SUBJECT: NFPA 1971 Proposed TIA No. 1594 **Circulation of TC Ballots**

NFPA 1971-2018 Edition

Standard on Protective Ensembles for Structural Fire Fighting and Proximity Fire Fighting

TIA Log No.: 1594

Test Method	Test Method Description	Test Method Application
	Exterior of Xenon Apparatus.	
	Interior of Xenon Apparatus in Use.

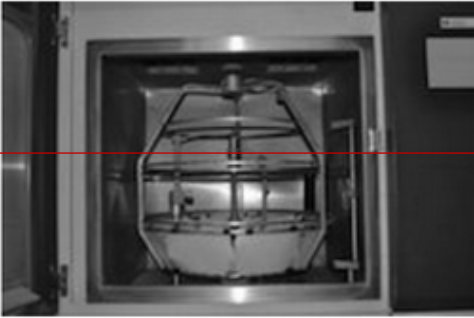
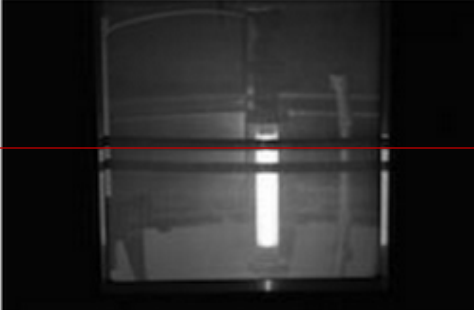
5. Delete the line entry 7.1.23, and photos for “Exterior of Xenon Apparatus” and “Interior of Xenon Apparatus in Use”, and update the cross references in Table B.2 Garments as shown here:
